Report To:	The Planning Board	Date:	4th March 2009
Report By:	Head of Planning and Housing	Report No:	08/0157/IC Plan 03/09
Contact Officer:	Jane Shields	Contact No:	01475 712423
Subject:	Erection of six lighting columns each carrying two 2KW metal halide floodlights at Birkmyre Park Playing Fields Knockbuckle Road Kilmacolm

Figure 1:

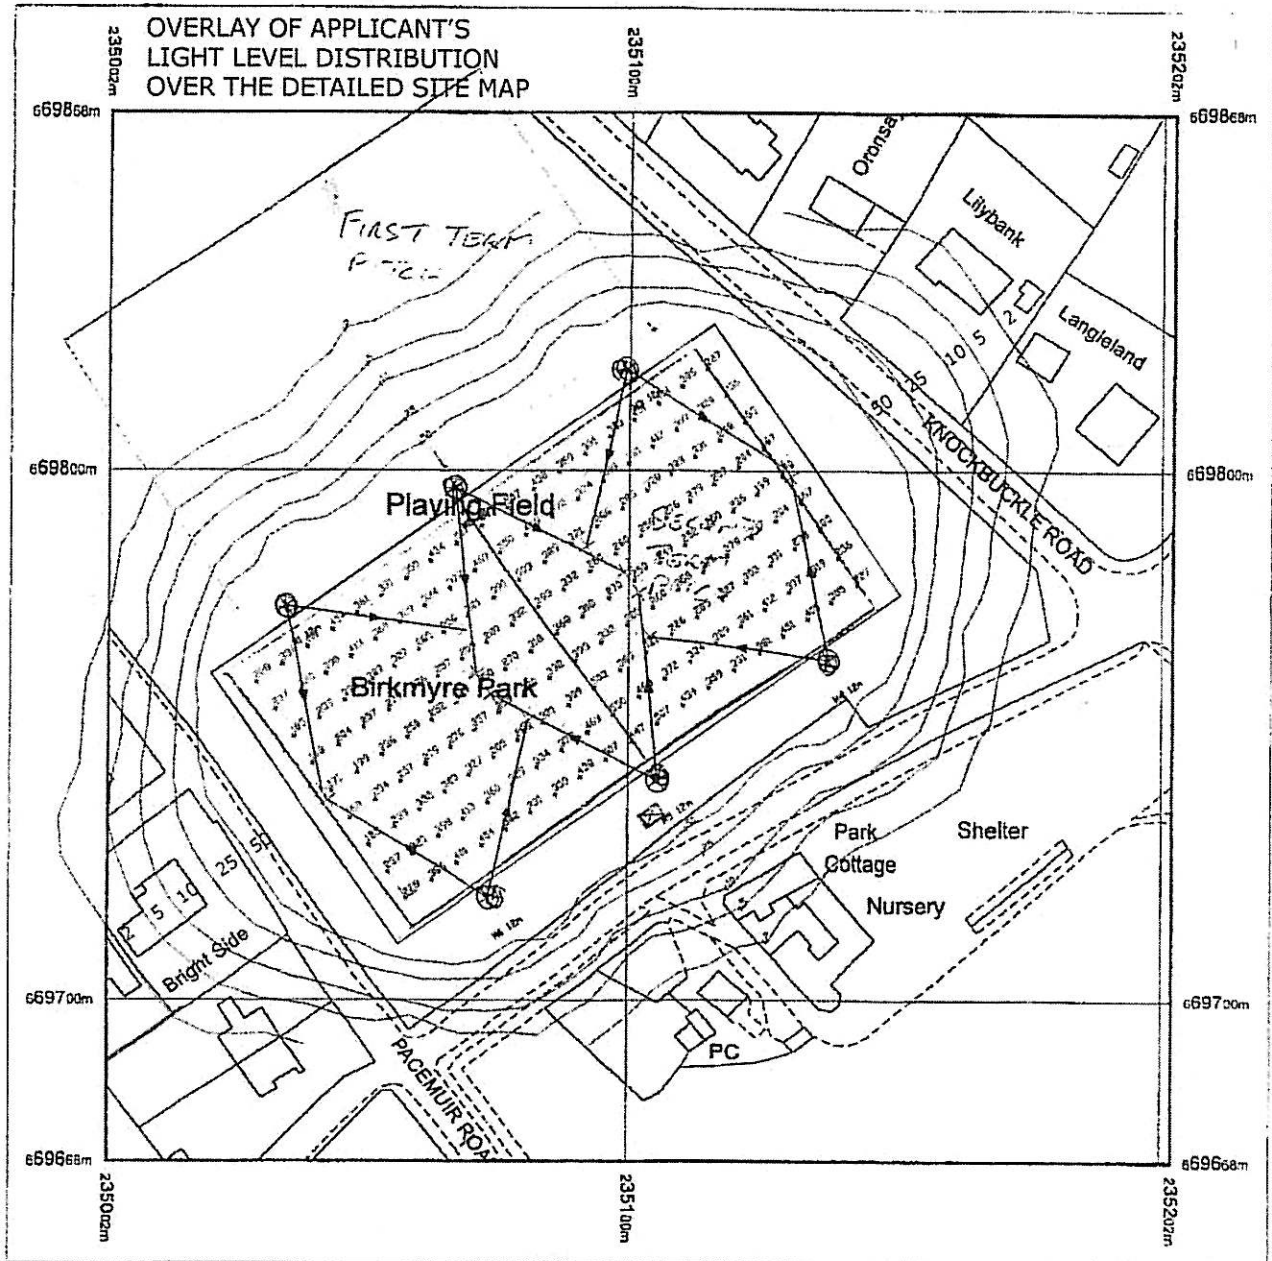
From the combined lighting plot and site plan, figure 1 attached, it is clear that the area affected by the floodlighting is huge. When in use, the light will dominate the environment of the park from end to end, it will overspill onto adjacent roadways and gardens, and will shine directly into the windows of a number of neighbouring properties.

The combined lighting plot and site plan, figure 1 attached, shows contour lines of 50, 25, 10, 5 and 2 Lux. Only the outermost contour, with a value of 2 Lux, is below the lighting nuisance limit. The plot shows a nuisance level of light encroaching on a number of neighbouring properties and in the case of the property Bright Side at the South West corner of the playing field the level is between 10 and 25 Lux which is between 2 and 5 times the nuisance limit for light trespass.
